**ALERT SERVICE BULLETIN**  
REVISION NOTICE

**SUBJECT: REVISION "A" TO ALERT SERVICE BULLETIN 205B-09-54:  
TAIL ROTOR BLADE P/N 212-010-750-ALL, INSPECTION OF.**

NO. 205B-09-54  
DATE Nov 09, 2009  
PAGE 1 of 5

**SUBJECT:** TAIL ROTOR BLADE P/N 212-010-750-ALL, INSPECTION OF.

Figure 1

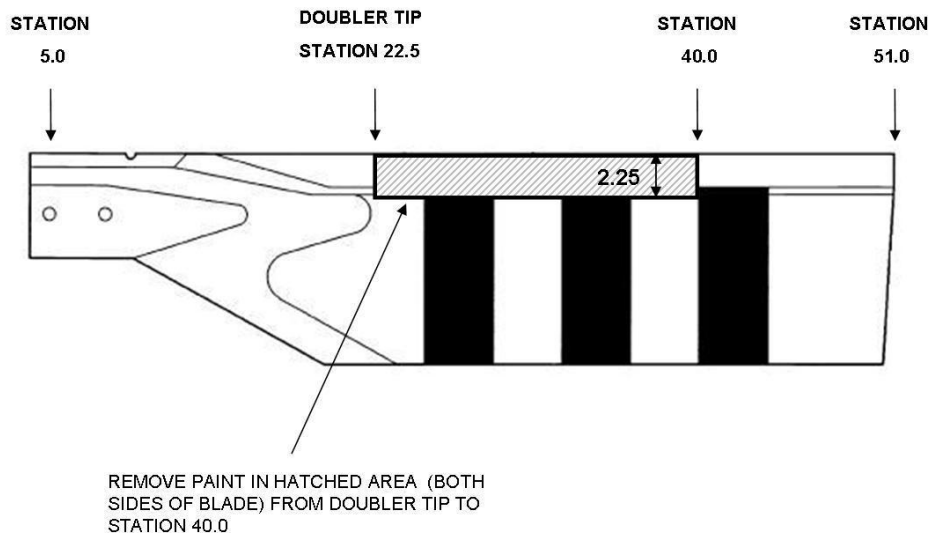
4. Ensure that all paint (on the spar only) is removed from the first 2.25 inches of the leading edge (chordwise) and from the B.S 22.5 (doubler tip) to B.S. 40.0. Refer to Figure 1. This will expose the spar up to the fillet between the blade spar and skin. A fillet filled with adhesive runs spanwise between the blade spar and the skin 2.25 inches aft of the blade leading edge, both inboard and outboard sides. The area to be inspected runs along the edge of the spar fillet and a half inch forward of this point. (Between 1.75 and 2.25 inch from the leading edge of the blade and from Blade Stations 22.5 to 40.0, both inboard and outboard sides).

5. Wipe area with a clean cloth dampened with alcohol (C-385) or aliphatic naphtha (C-305) and dry thoroughly.
6. Carry out a detailed visual inspection of the spar for corrosion and/or pitting using a 3-power or higher magnifying glass. Anomalies on the steel spar 0.003 inch deep or less must be polished out in accordance with BHT-205A1-MM.

Any defect greater than 0.003 inch deep is cause for rejection and the blade must be removed from service.
